# Rezoning Transportation Analysis

Petition Number: #2022-048

**Reviewer: Travis Miller**  
Travis.Miller@Charlottenc.gov  
980-221-5778

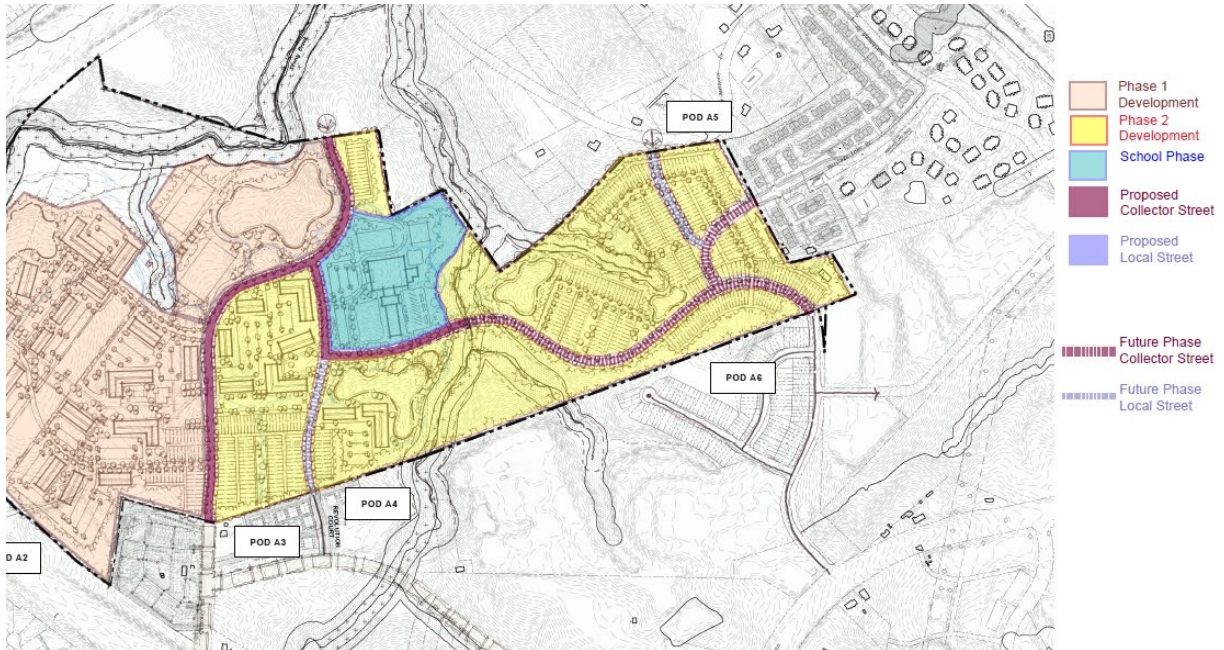
~~Clarifying Comment 04-25-23: Revise conditional note to say "Petitioner shall coordinate with CDOT to upgrade pavement and stormwater infrastructure along Northbend Drive and Heritage Lake Drive to public street standards in coordination with CDOT street acceptance team during permitting, as improvements are reasonably able to be completed within the existing right of way and no additional right of way acquisition would be required to perform the improvements"~~

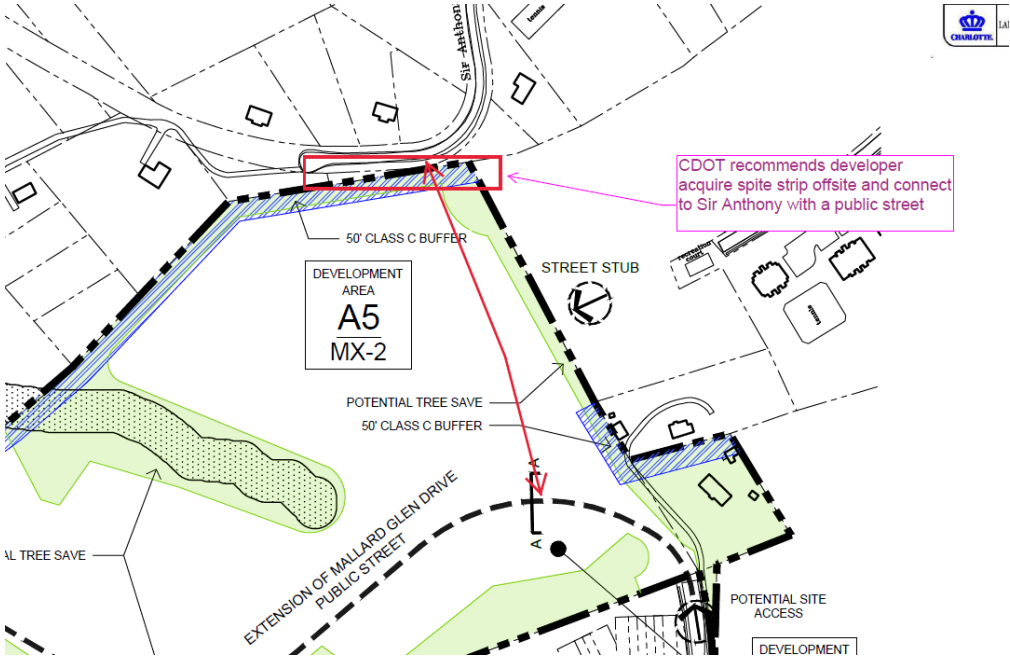
- ~~5. Add conditional Lighting Note for petitioner to coordinate with CDOT Lighting, Bruce Horltdt (704-589-5836 or Bruce.Horltdt@charlottenc.gov), prior to permitting of lighting fixtures on public roadways.~~
- ~~6. **CDOT RECOMMENDATION:** CDOT recommends the petitioner commit to providing a public street connection to Sir Anthony Drive.~~
